Comment Set B.11: Lauren Development, Inc. - for Valley Vineyards, LLC

Re: Draft Environmental Impact Report / Environmental Impact Statement on Southern California Edison's Antelope-Pardee 500-kV Transmission Line Project

## Response to Comment Set B.11: Lauren Development, INC. - for Valley Vineyards, LLC

1. Map "VALLEY VINEYARDS – Western Portion" showing overlay of Alternative 5 on Valley Vineyards residential community.

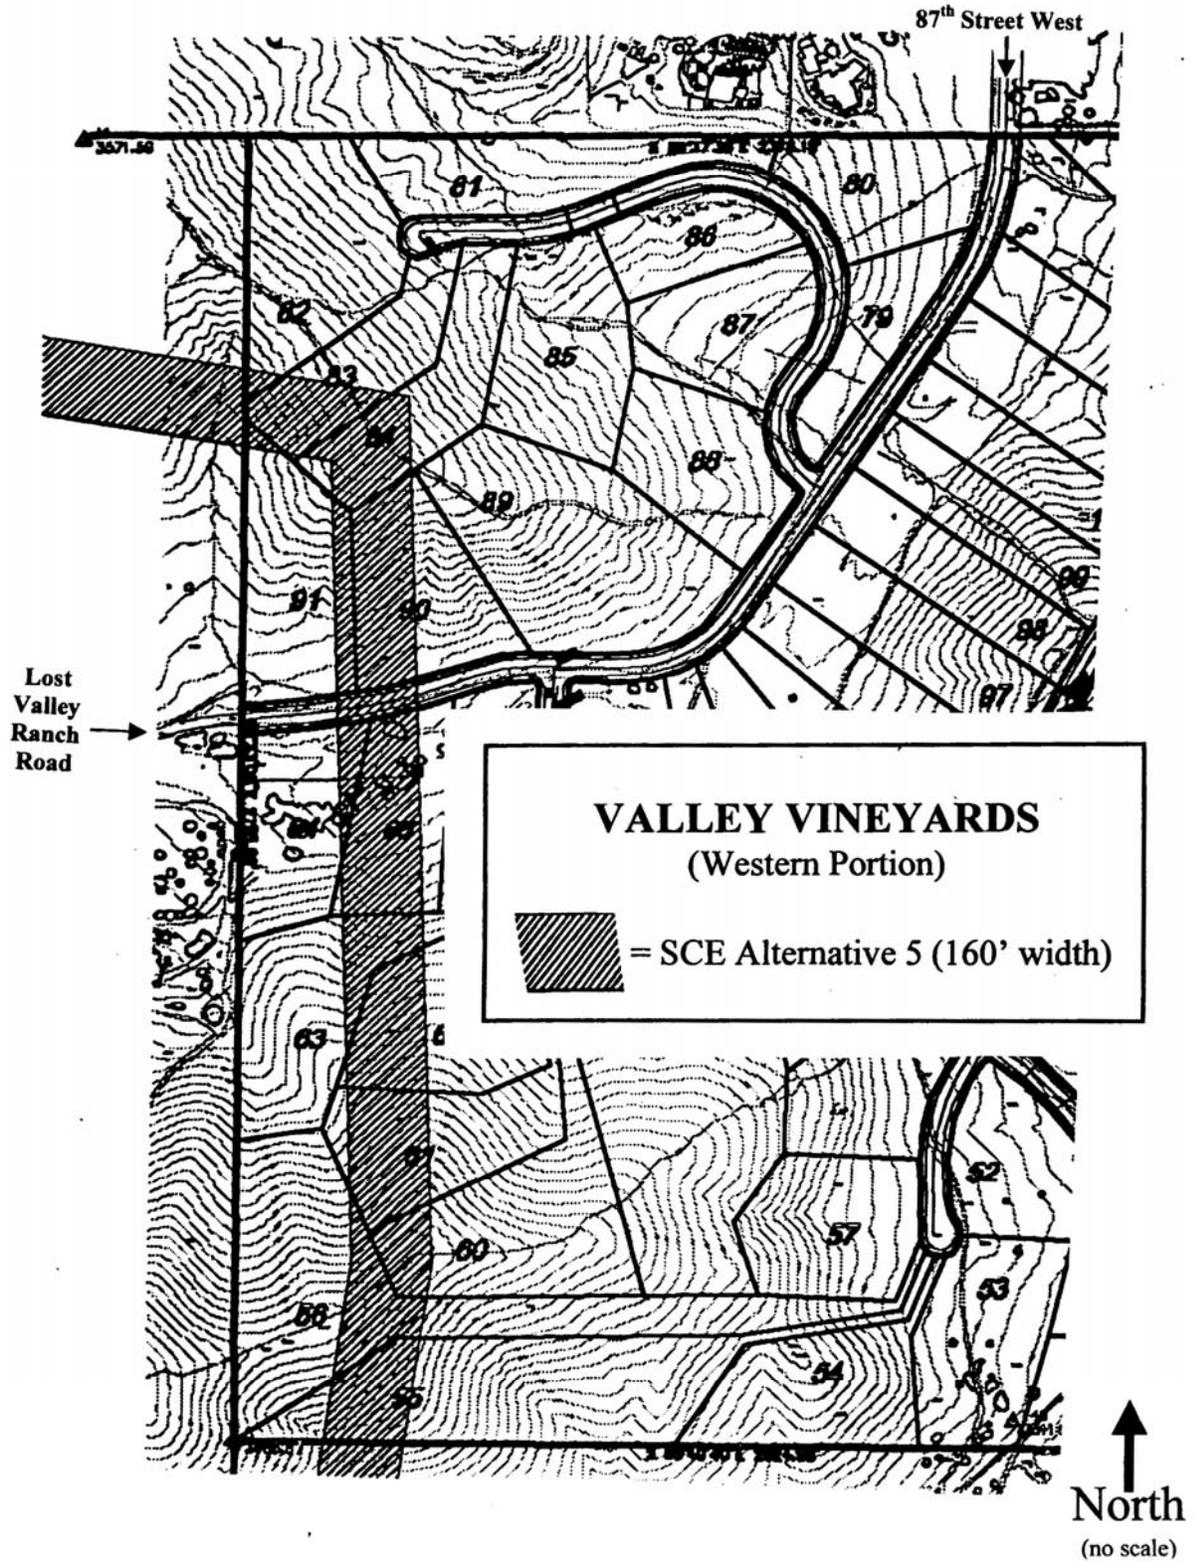
Land planning for the residential development of the Valley Vineyards residential development is well underway. Route Alternative 5, from approximately Mile 8.3 to Mile 8.8, runs through the Valley Vineyards community. At least two transmission towers in Alternative 5 are on Valley Vineyards property. Residential lots are planned for the land where the towers are proposed and for the land under the transmission lines.<sup>2</sup>

<sup>2</sup> See attached plan "VALLEY VINEYARDS – Western Portion" which shows the area impacted by Alternative 5.

At approximately Mile 8.3 to Mile 8.6, Alternative 5 runs through a 290 acre, 140± home residential community – “Valley Vineyards” – currently in the engineering stages. Two transmission towers are proposed where homesites are located and the transmission line itself goes directly over other proposed homesites.

- B.11-2 The EIR/EIS preparers provided maps that were the most current available at the time the Draft EIR/EIS was prepared and understand that recent development would not be reflected. Site visits were conducted in May and July 2005 to verify conditions and note new development; however, due to how much development is currently occurring in the Santa Clarita area at this time, not all new development would have been assessed in the Draft EIR/EIS. Per CEQA Guidelines Section 15125 (a), the baseline environmental conditions by which the lead agency determines whether an impact is significant is established based on the physical environmental conditions at the time the notice of preparation is published. The notice of preparation was published and available for public review June 28, 2005. As noted in Draft EIR/EIS Section B.5, Cumulative Impacts Scenario, the cumulative projects presented in Table B.5-1 reflect projects provided by the County of Los Angeles Regional Planning Department as of October 2005. As noted, the County did not assign a tract map number until May 1, 2006. As such, this project was not identified at the time the Draft EIR/EIS was prepared.
